TECHNICAL BULLETIN INDEX  
Sorted by Bulletin Number  
04/03/86

DATE: March 20, 1984  
REVISION DATE: March 20, 1984  
BULLETIN NO.: 4P:5  
PRODUCT: 26-1080 Model 4P  
SUBASSEMBLY: CPU board

PURPOSE: Prevention of RAM problems due to glitch in the 240ns delay tap output.

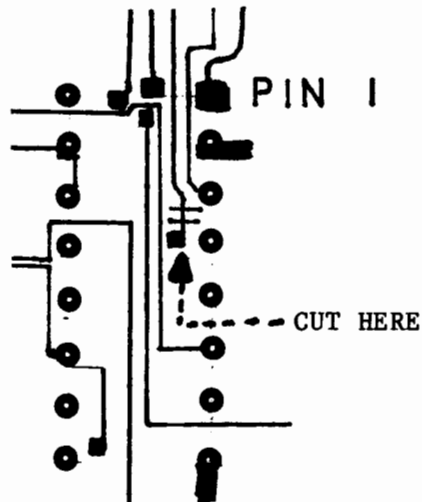
**DISCUSSION:** There is a glitch in the 240ns delay tap of Valor delay devices with a date code of 8351 or less. This glitch causes RAM problems, usually preventing the unit from booting. In the following procedure, "anding" the 150ns, and the 240ns delay tap, stabilizes the 240ns line to properly clock U115.

- 1.) Cut the run to the solder pad NEXT to U115 pin 4. (see attached art work)
- 2.) Jumper from U129 pin 8, to U115 pin 13.
- 3.) Jumper from U129 pin 9, to U97 pin 10.
- 4.) Jumper from U129 pin 10, to U97 pin 6.
